SUMMARY OF CONCERNS IN RELATION TO THE PROPOSED NORTHCONNEX TUNNEL

SECTION A: THE CONNECTIVITY OF NORTHCONNEX SOUTHERN VENTILATION FACILITY AT THE SOUTHERN INTERCHANGE, THE SOUTHBOUND TUNNEL IN PARTICULAR

Figure 5-17 Motorway operations complex

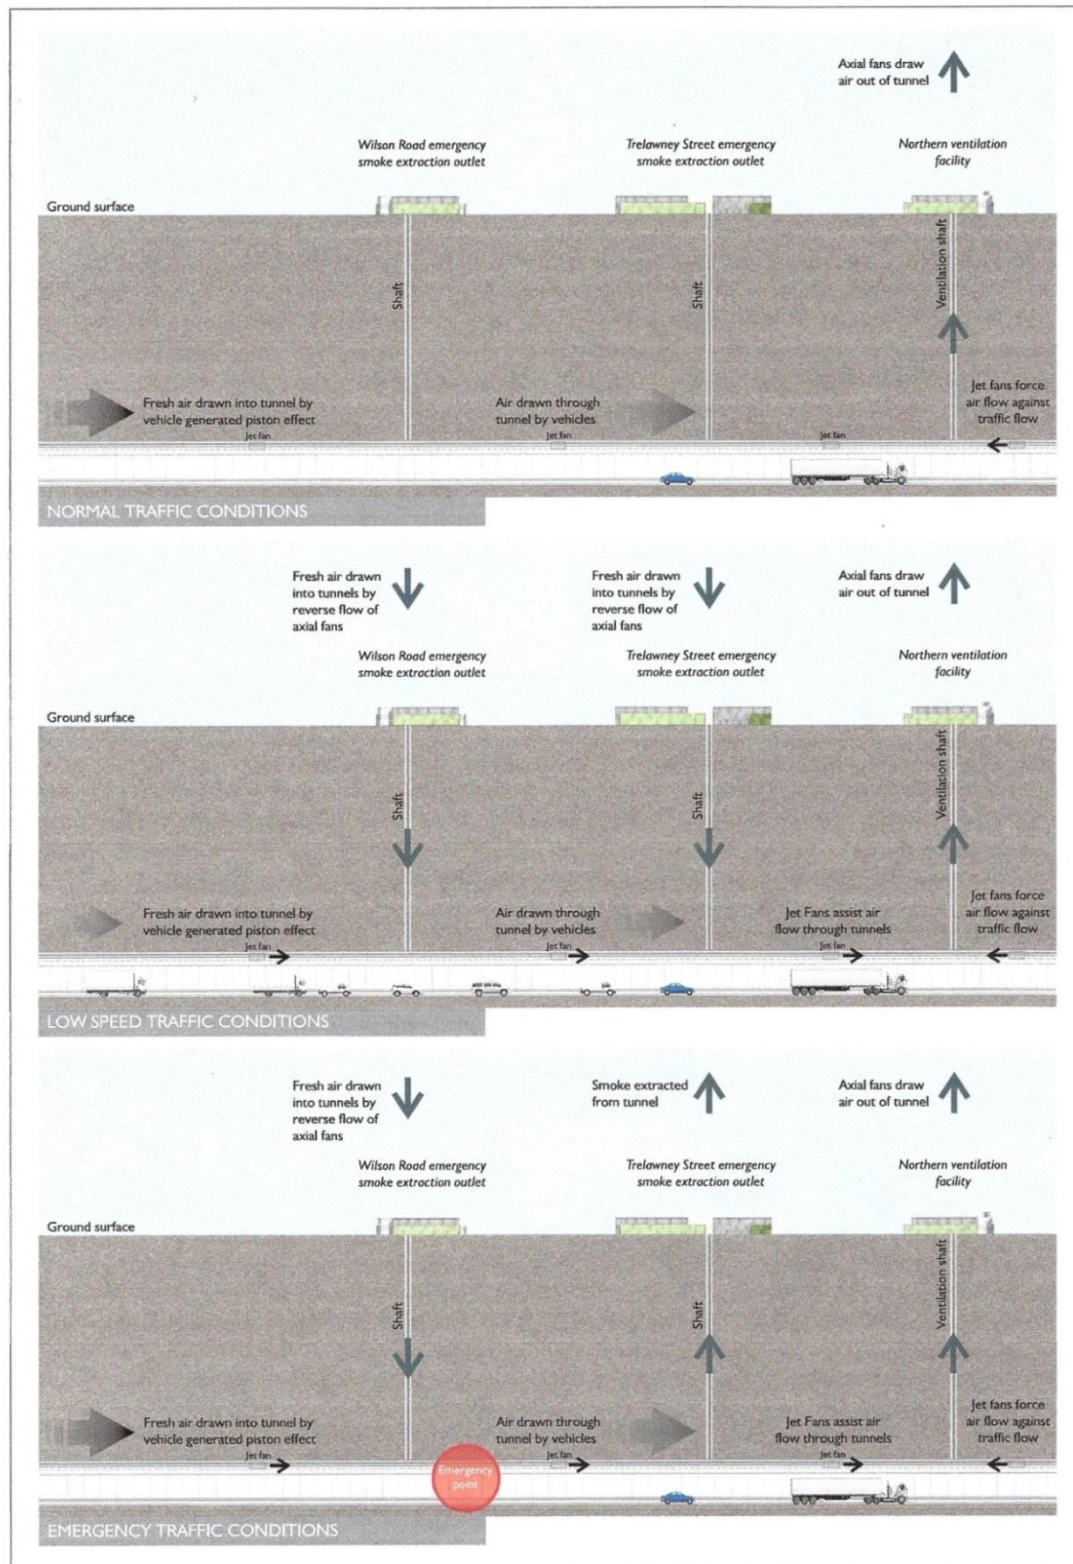
EIS Page 111, *Figure 5-17 Motorway operations complex*

Page 8 below there is no indication of how the ventilation facility will be connected to either the northbound or southbound tunnel, nor is there any indication of how the southbound exit portal onto Pennant Hills Road or the south-west exit portal onto the M2 will be connected.

Figure 5-38 Indicative southern interchange construction compound

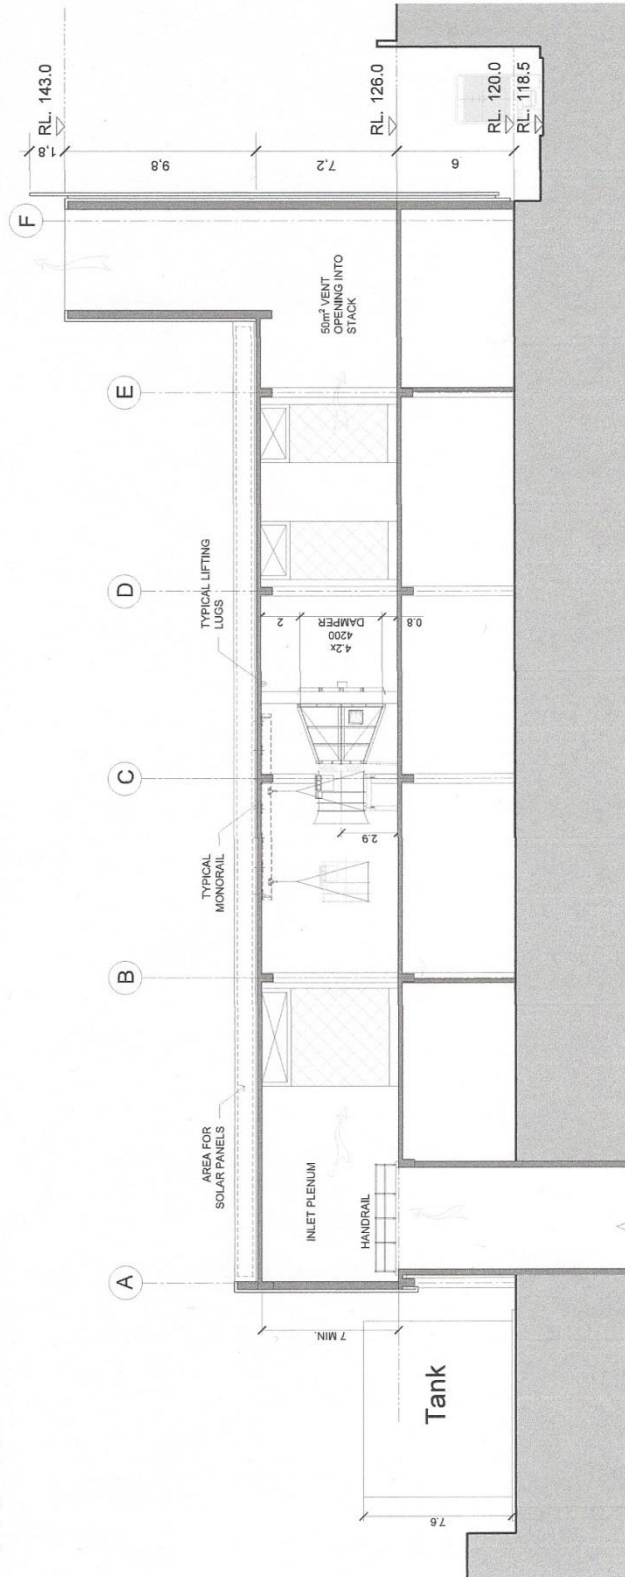
3. EIS Page 189 *Figure 5-38 Indicative southern interchange construction compound* *Page 9 below*

It is ominous that the southern ventilation facility and shaft are completely absent from Figure 5-38.

MOTORWAY OPERATIONS COMPLEX - SOUTHERN VENTILATION FACILITY - SECTIONS
M1-M2-5000-DR-JD-0525

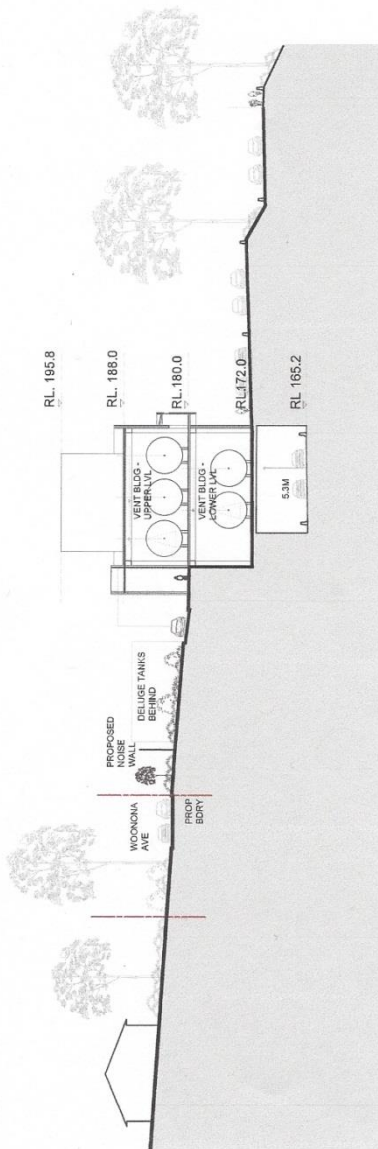
5. *EIS Volume 4, Technical working papers - Urban Design, 6.0 Operational Ancillary Facilities*
EIS Page 99 there is the diagram "Motorway Operations Complex – Southern Ventilation Facility – sections. *Page 10 below* The diagram has the cryptic label "Connection to tunnel TBC". What does TBC stand for? To be considered? Why is tunnel singular? Which tunnel is the diagram referring to northbound or southbound? There is no diagram showing any connection from the Southern Interchange ventilation facility to either the northbound or the southbound tunnel in any way AND YET

- Will the Southern Ventilation facility be connected to the southbound tunnel? In the complete absence of any indication in the EIS that this will occur, it is necessary that this question receive a direct confirmation or denial in writing.
- Where will the connection be?
- How will the polluted air from the tunnel reach the ventilation facility which is across a busy 6-lane highway?
- A diagram such as that in the EIS Page 103, *Figure 5-14 Indicative tunnel ventilation system northbound tunnel arrangement* must be provided showing how this will work for the southern interchange. Clearly the polluted air cannot be drawn upward if the ventilation facility is across the road.

- Diagrams need to be provided showing the inter-relation between the shaft, the ventilation outlet and the motorway operations centre with a clear description of what is to be constructed and how it will operate.
- The community needs irrefutable evidence that the polluted air from the southbound tunnel exit portals will not be allowed to flow like an invisible sewer through West Pennant Hills, North Rocks, Carlingford and Beecroft.

MOTORWAY OPERATIONS COMPLEX - SOUTHERN VENTILATION FACILITY - SITE SECTION 1-1
M1-M2-5000-DR-UD-0713

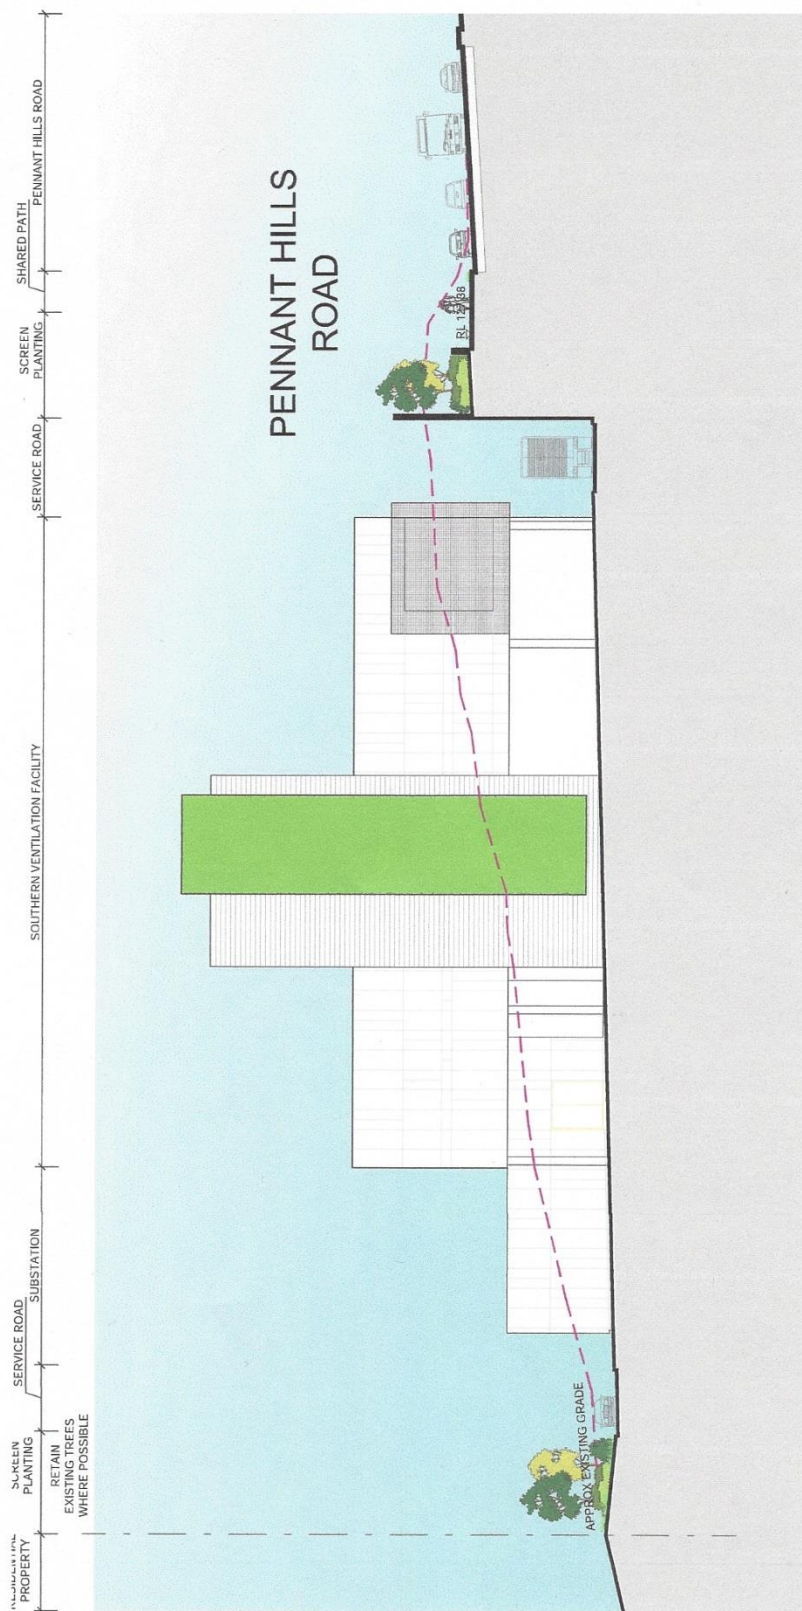
6. *EIS Volume 4, Technical working papers Urban Design, 8.0 Landscape Design*
EIS Page 176 is the diagram "Motorway Operations Complex – Southern Ventilation Facility – Site 1-1". *Page 13 below* The diagram does not show any connection to either the northbound or southbound tunnel. In the same Landscape Design section, EIS Page 182 is the diagram "Wilson Road Tunnel Support Facility –Section" *Page 14 below* which clearly shows the connection to the tunnels. In the same Landscape Design section, EIS Page 189 is the diagram "Northern Ventilation Facility – Landscape Concept Section". *Page 15 below* This also clearly shows the connection to the tunnels.
